MFN 08-760

Docket No. 52-010

**Subject: Response to Portion of NRC Request for Additional Information Letter Nos. 227 and 226, Related to ESBWR Design Certification Application - Auxiliary Systems - RAI Numbers 9.5-73 and RAI 9.5-75**

**\*Response to Portion of NRC Request for  
Additional Information Letter Nos. 227 and 226  
Related to ESBWR Design Certification Application  
Auxiliary Systems  
RAI Numbers 9.5-73 and 9.5-75**

Figure 2.16.3-1. Fire Protection System

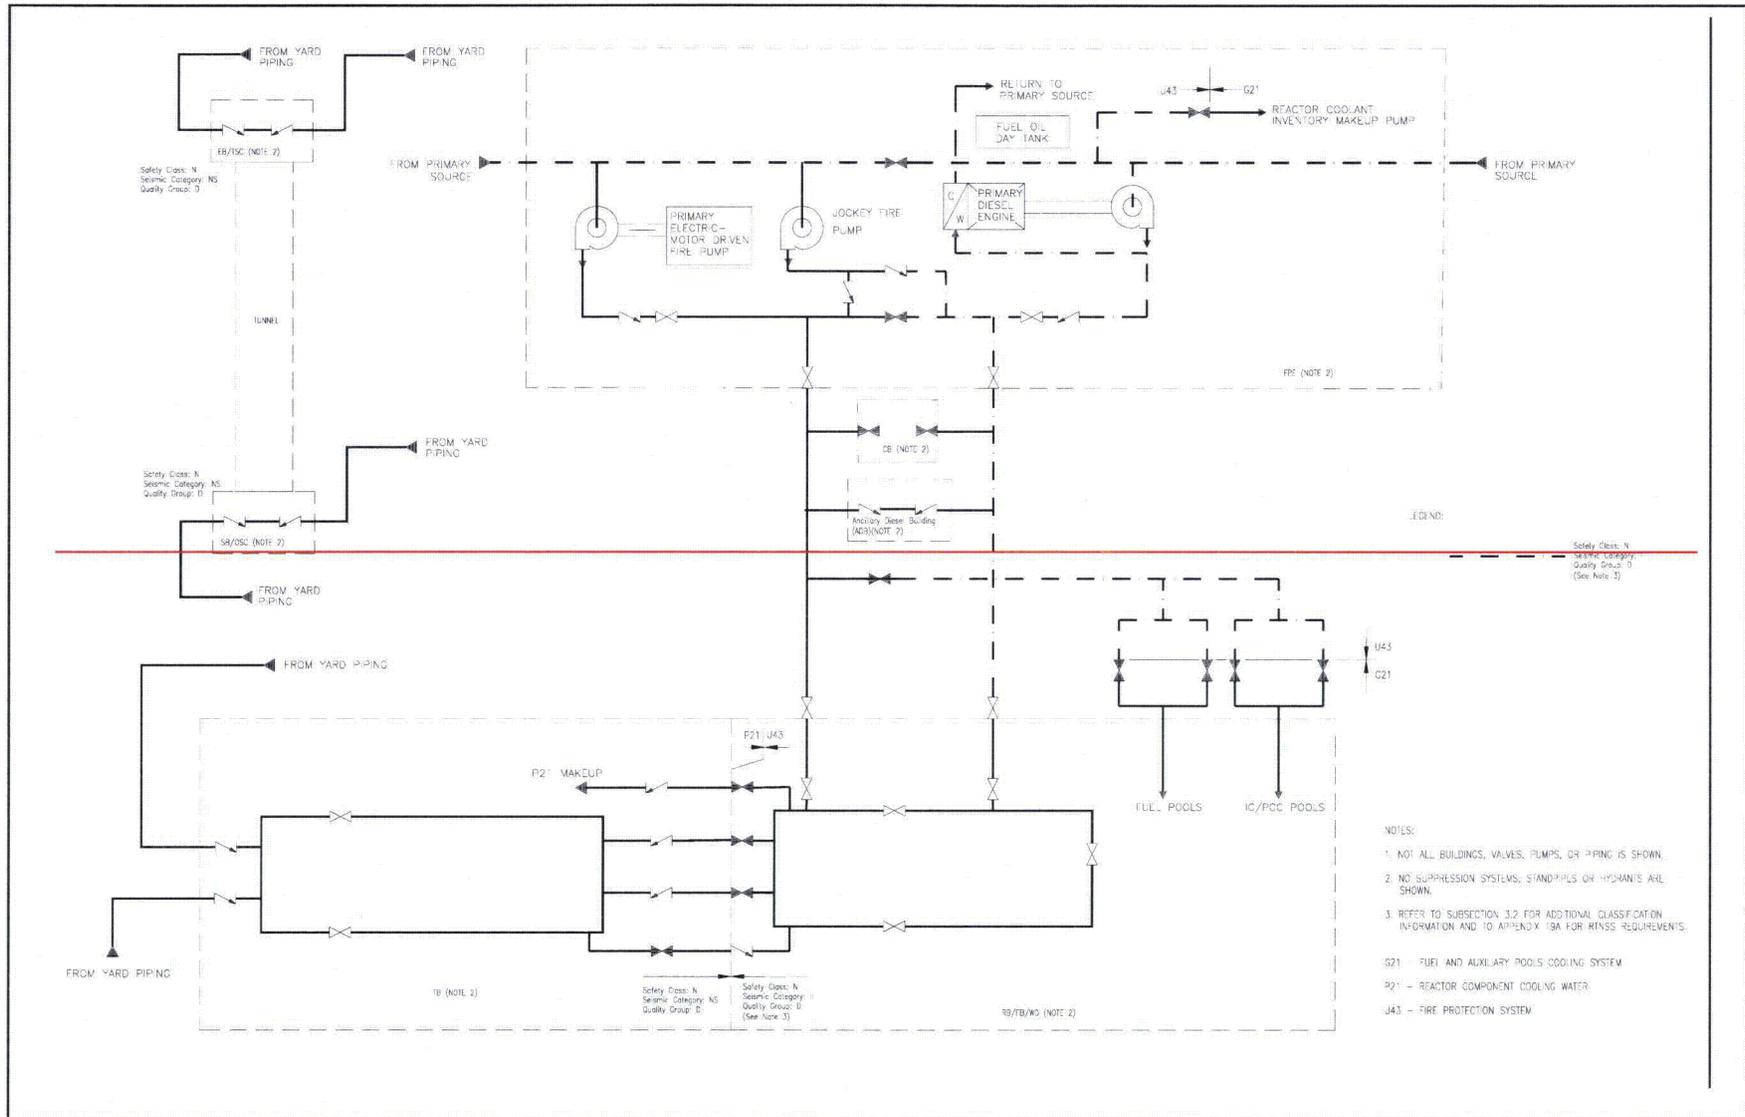
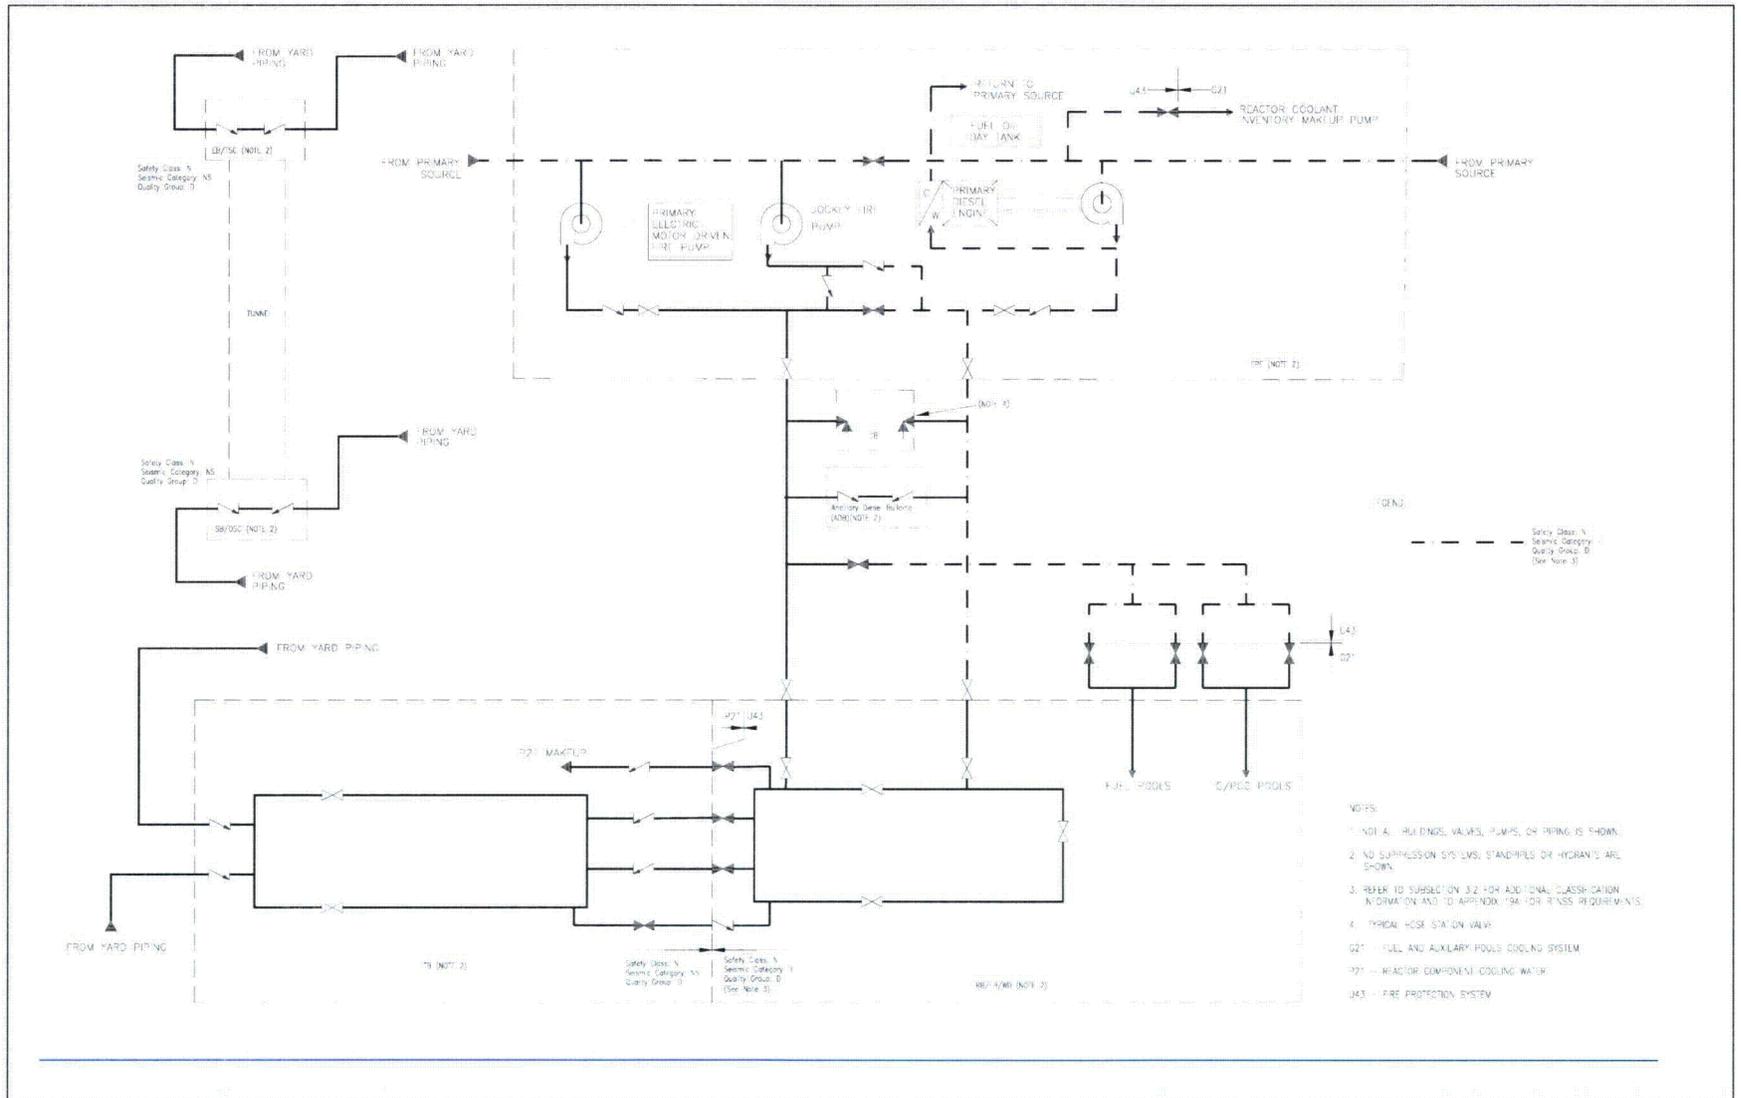
*In DCD Tier 1 Figure 2.16.3-1 the fire protection header supply lines feeding the control building indicate that the lines will be normally isolated from the fire water supply. The fire water supply should be available at the control building hose stations by opening the hose valve at each hose station. GEH should revise this drawing or provide justification for normally isolating the fire water supply lines to the control building. (Note that this comment also applies to Tier 2 Figure 9.5-1, which replicates Figure 2.16.3-1)*

The valves inside the Control Building on ESBWR DCD Tier 1 Figure 2.16.3-1 and Tier 2 Figure 9.5-1 do not represent header isolation valves; the purpose of these valves is to symbolize the hose valves at each hose station. Note 2 on DCD Tier 1 Figure 2.16.3-1 and Tier 2 Figure 9.5-1, indicates that no suppression systems or standpipes are shown. Therefore, a new Note will be added for the Control Building for these valves to clarify that these valves represent a typical hose station valve.

DCD Tier 1 Figure 2.16.3-1 and Tier 2 Figure 9.5-1 will be revised to clarify that the closed valves represents a typical hose station valve.
